STAFF REPORT  
E & M REMODELING & CONCRETE  
SIX-PUMP GAS STATION  
CONDITIONAL USE PERMIT CUP 1-23  
APRIL 19, 2023

City of Cottage Grove File(s): CUP 1-23 and SDR 1-23

**Subject: Engineering Review Comments  
Hillcrest Market Site Review and Conditional Use Permit**

Figure 14.23.180.A(1) Drive-Up and Drive-Through Facilities

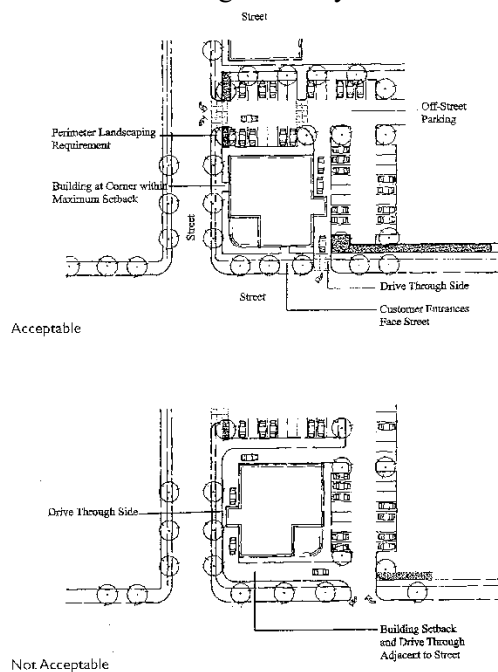
The applicant has proposed the location of the drive-up facility (gas pumps) to be located at the west side of the proposed development between the right-of-way and the entrance to the walk-up retail space located on the eastern half of the development site. There are parking spaces for the retail space located on the north side of the proposed new building with a direct pedestrian connection to the convenience store. The proposed layout does not meet the code standards for location of the drive-up use, however given the constraints of the development site, the adjacent un-incorporated uses of single-family dwellings abutting the subject property to the north, east, and south, and the concerns expressed by the

neighbors regarding vehicle movements, including delivery vehicles, the proposed layout is the best use of the development site that also mitigates the impacts to adjacent uses while providing adequate space for vehicle movements. To address pedestrian access to the convenience store from the right-of-way to the entrance of the building the applicant has proposed a delineated ADA accessible path from the right-of-way east to the store entrance. As proposed staff recommends approval of the proposed configuration of the site plan.

The applicant has proposed a site layout that maximizes the lot for the use. While the proposed siting of the drive-up facilities (gas pumps) does not meet the code the vehicle circulation pattern allows for drive-up fueling and access to the convenience store in a way that is logical for a gas station use. Pedestrian access from the right-of-way to the building entrance will be provided via a clearly delineated ADA accessible pedestrian path.

Re: Proposed Site Plan

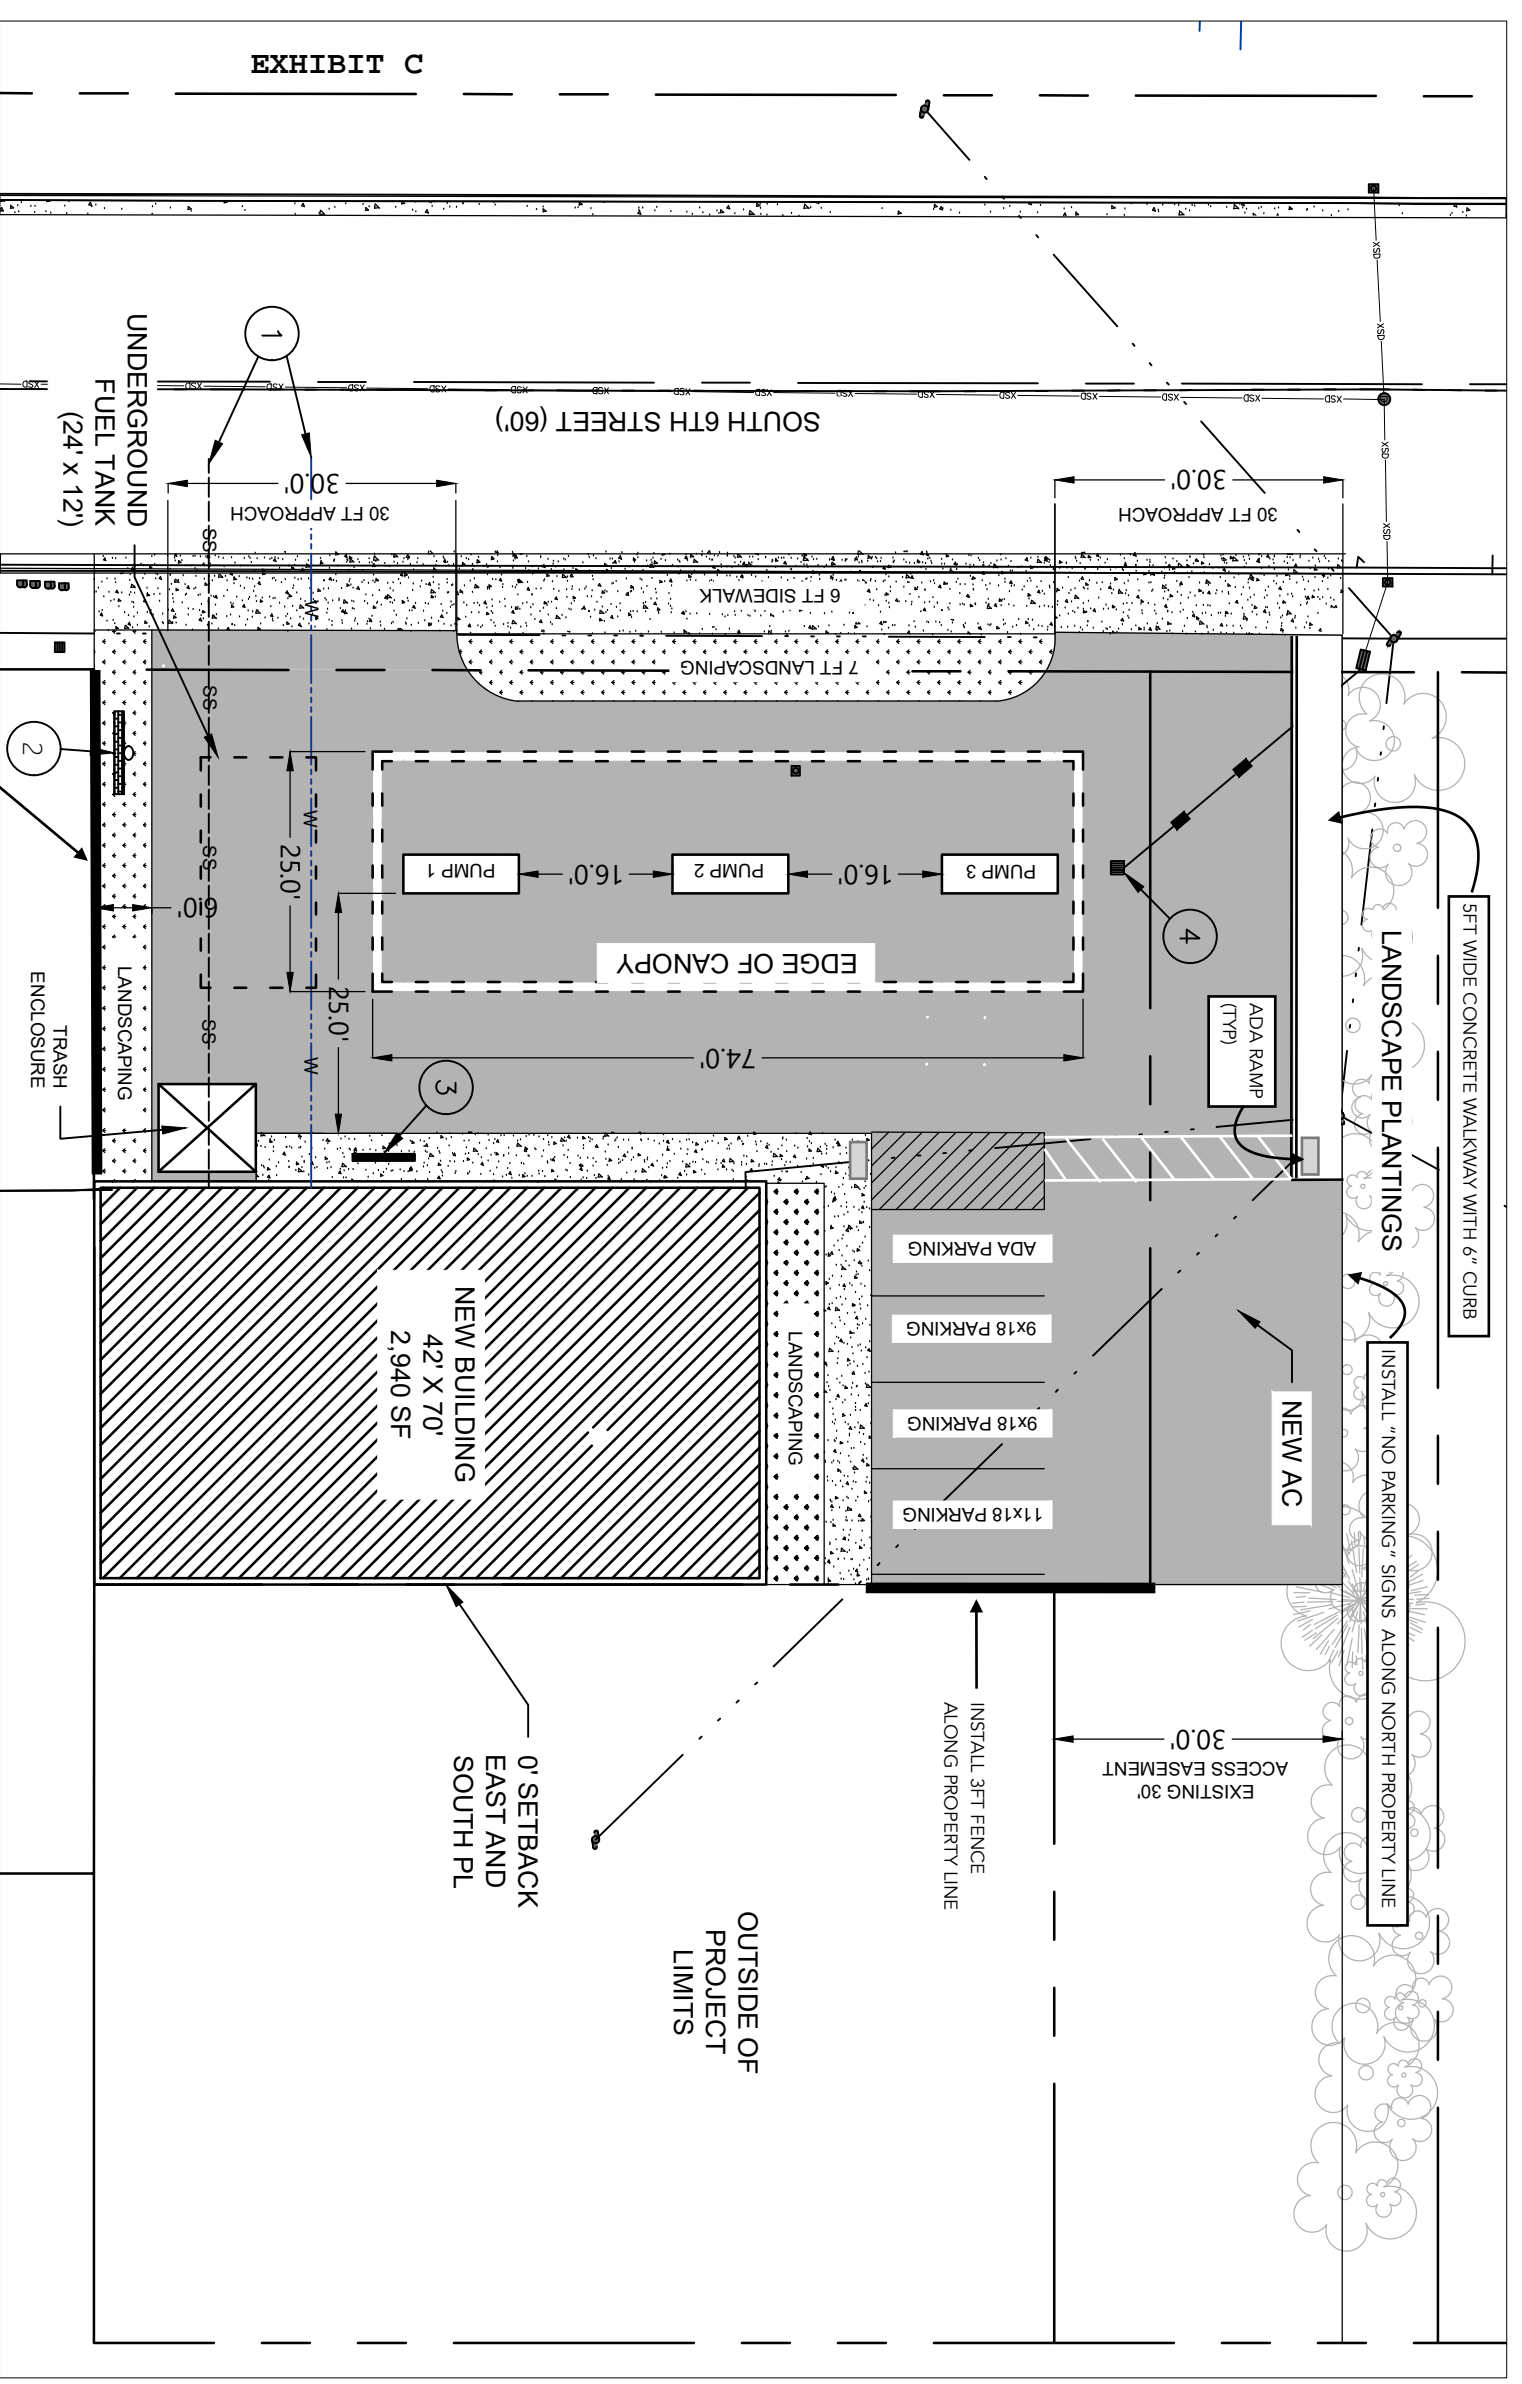
- ~ The setback means the building roof and /gutter should not cross the property line.
- ~ What will the outside walls be constructed of, since future access could be denied?

- ~ What is the height of the back and side walls? At this point there does not seem to be enough space for customers to park, since many times there can be as many as six cars at the store. We don't see any additional parking shown in front.

- ~ Will the (access) easement be paved or left as gravel? *Paved*
- ~ Where are the provisions for ample parking?
- ~ There does not seem to be enough space for a semi truck to unload goods. Truck parking on the road blocks the view of north bound traffic coming into town. Trucks parking on the road block the view of traffic from the easement.

- ~ Will the store take an active approach to removing the nuisance ~~the nuisance~~ of the easement being blocked by delivery trucks?
- ~ The side parking is not enough.

- ~ Light pollution is a concern. Will the canopy lights be on 24-7? *NO*
- ~Is there a plan for delivery trucks to park in front of the dumpster?
- ~Will the delivery trucks park in the middle of 6<sup>th</sup> Street as they do in other areas of town?

- ~The proposed site plan is 110 by 95, leaving little or no room for deliveries. Using the easement is not what the easement is designed for.
- ~Our hope is that there will be a fence from the north back corner to the end of the parking space. The parking we use on our side of the fence is not for store parking.

- ~ We are concerned about water runoff from the canopy and the roof is drained into the storm system. In the proposed site plan, the canopy is over the easement. That is not right.

- ~ We hope the back wall will not have windows. *NO*
- ~Will the store only have restrooms that can be accessed from the inside? *inside*
- ~With wells being so close to the proposed gas-holding tanks, is there a guarantee of no contamination to well water?

- ~ An ambulance is approximately 8 ft. wide and a fire truck is approximately 8 ft. wide as well. Most delivery trucks are 20 to 40 ft. long and approximately 10 ft. wide. A gas tanker truck is approximately 40 ft. by 8 ft. It is going to be tight for the tanker to off-load.

Title:  
**TRUCK TURNING PLAN**

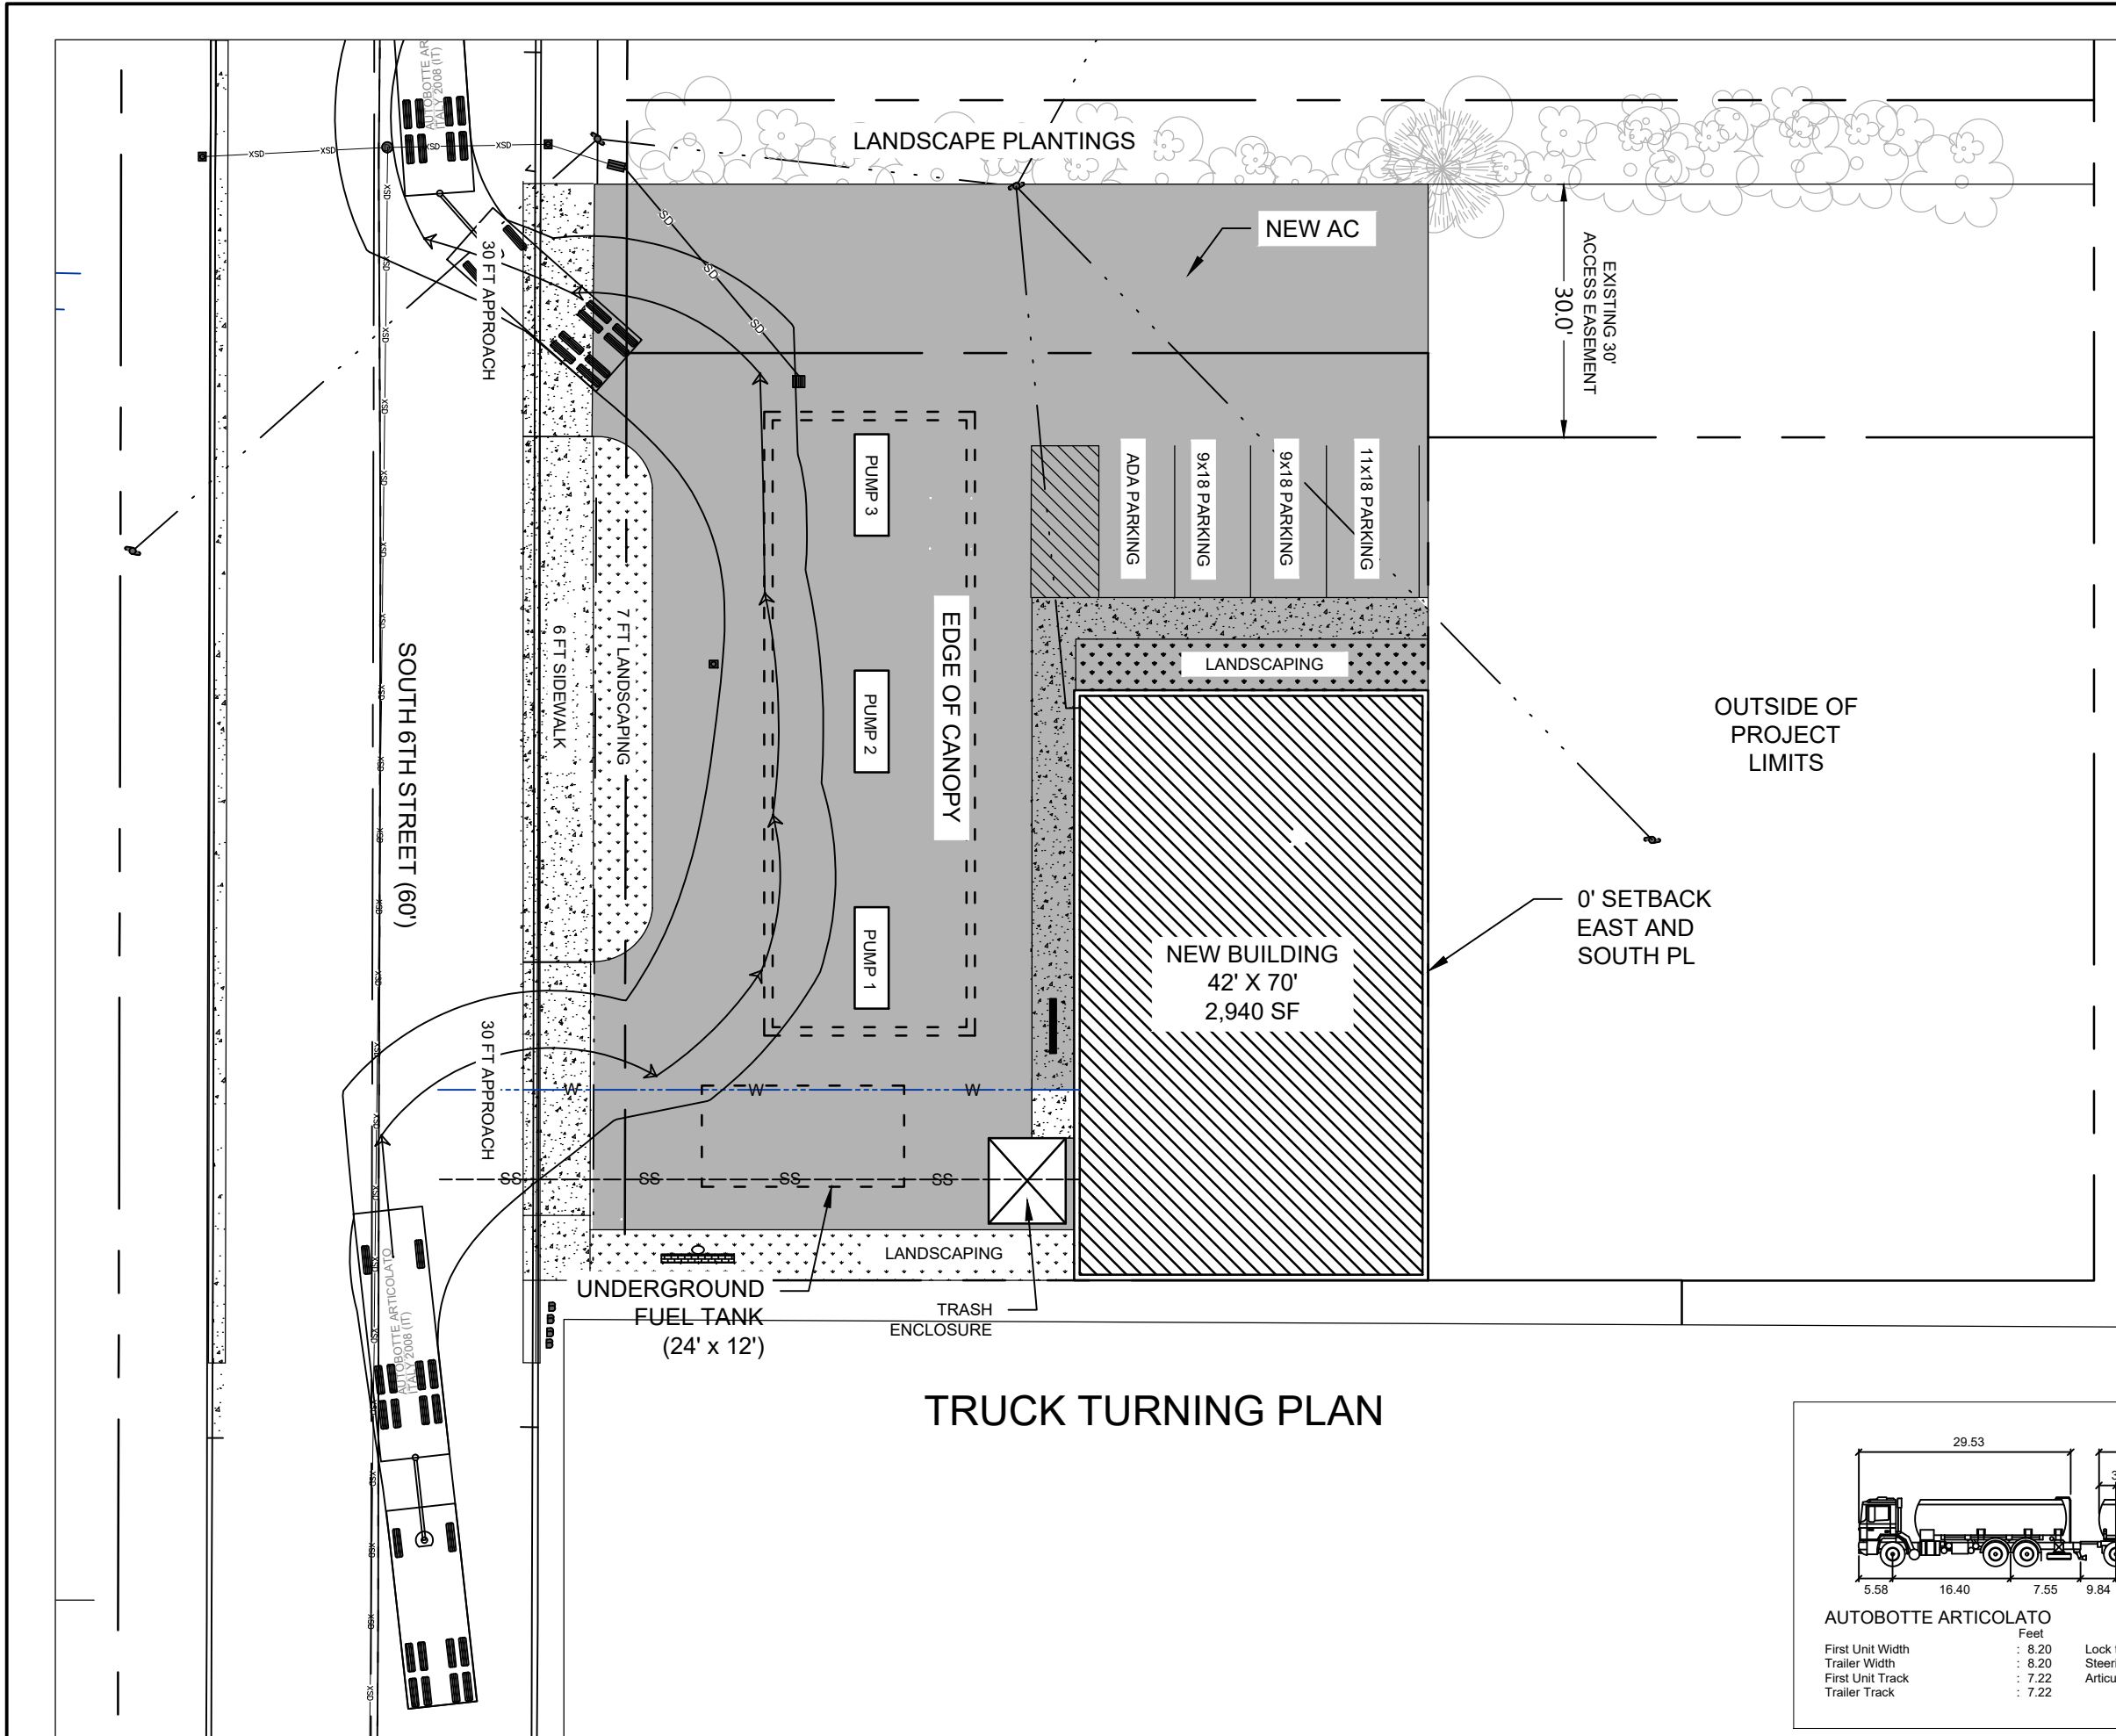
- Circulation diagrams were provided showing the path of travel for two design vehicles; a fuel tanker truck and an SUV.
  - o The submitted circulation diagrams shall be resubmitted with signatures included on the engineering seals as required by the board of engineers.

- o The construction documents anticipated to be reviewed during the building permit phase shall include details of delineation protecting amenities in the right of way such as water meters, and preventing the fuel tankers from tracking outside of the designed path of travel.

- o A plan showing merchandise delivery vehicle loading areas(s), and delineation/separation of large vehicles from queued fueling motorists shall be provided with the construction documents as well, with the focus on vehicles not having to stage, wait, or queue in the 6<sup>th</sup> street travel lane(s).
